File #: 17-522, **Version:** 1

Discuss and consider an appeal of the Non-Residential and Multifamily Design Standards and articulation requirements for a proposed diesel mechanic shop addressed at 556 Danken Lane in the "C-3" Commercial District.

Case No.: CS-17-014

Horizontal Articulation (Attachment 8, Chapter 144, Section 5.22-3(c)(1)):

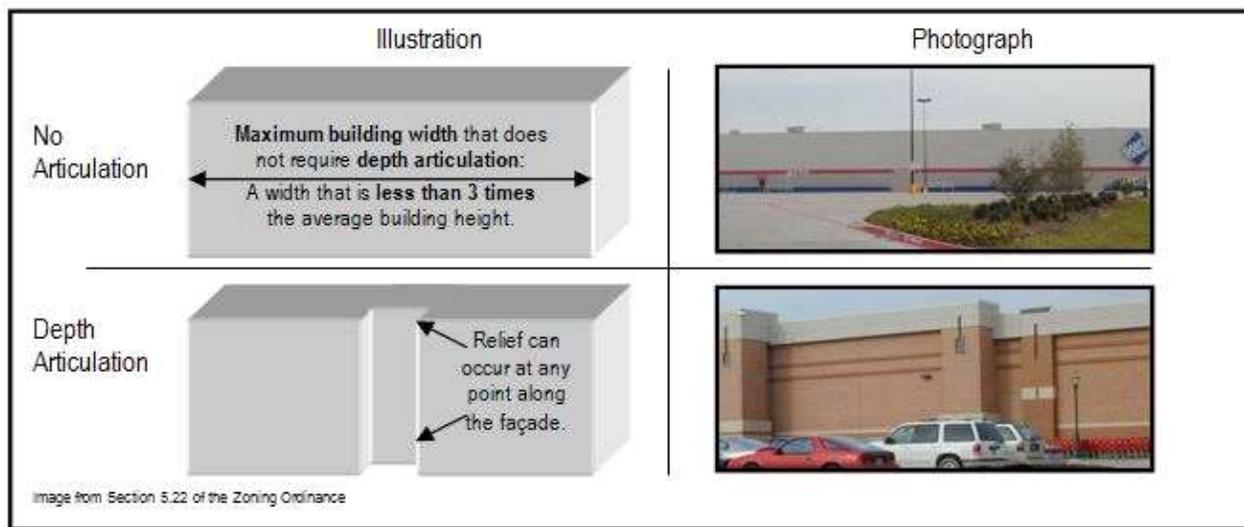
The horizontal articulation requirements for the proposed building only apply to the building facades facing Danken Lane and Executive Drive. The front facade as proposed would not meet the minimum horizontal articulation requirements. The width of the front façade is 180 feet with an average height of 20 feet. According to the design standards, no portion of the façade shall extend for more than three times the average height (60 feet) without depth articulation. To meet the design standards, there would need to be a minimum of 2 horizontal offsets (relief) at least 3 feet deep (15% of the average building height), extending a width of at least 18 feet (10% of the width of the building façade), positioned on the façade so that no portion of the façade would extend for more than 60 feet without an offset. The required offsets could be an inset or a protrusion as depicted in the following illustration:

Vertical Articulation (Attachment 8, Chapter 144 Section 5.22-3(c)(2)):

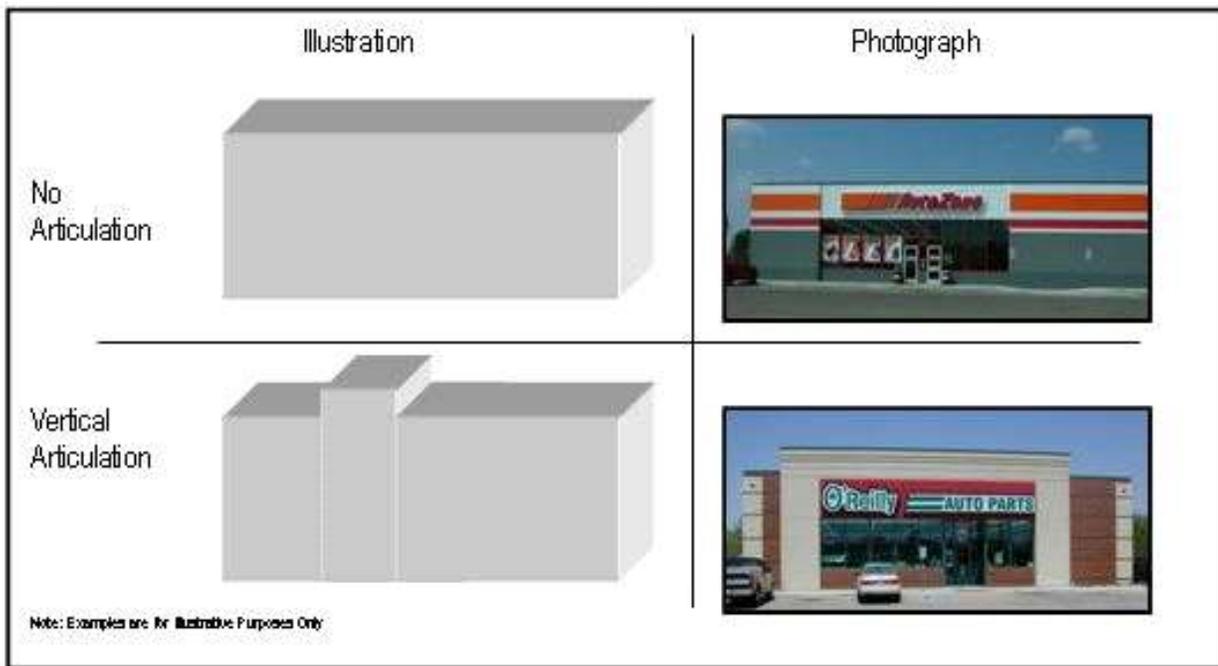
The Vertical articulation requirements for the proposed building also only apply to the building facades facing Danken Lane and Executive Drive. The front facade as proposed would not meet the minimum vertical articulation requirements. The width of the front façade is 180 feet with an average height of 20 feet. According to the design standards, no portion of the façade shall extend for more than three times the average height (60 feet) without a change in façade elevation. To meet the design standards, there would need to be a minimum of 2 vertical offsets (relief) with a change in elevation height of at least 3 feet (15% of the average building height), extending a width of at least 18 feet (10% of the width of the building façade), positioned on the façade so that no portion of the

façade would extend for more than 60 feet without an offset. The offsets can be of varying heights as long as the minimal standard is satisfied as depicted in the following illustration:
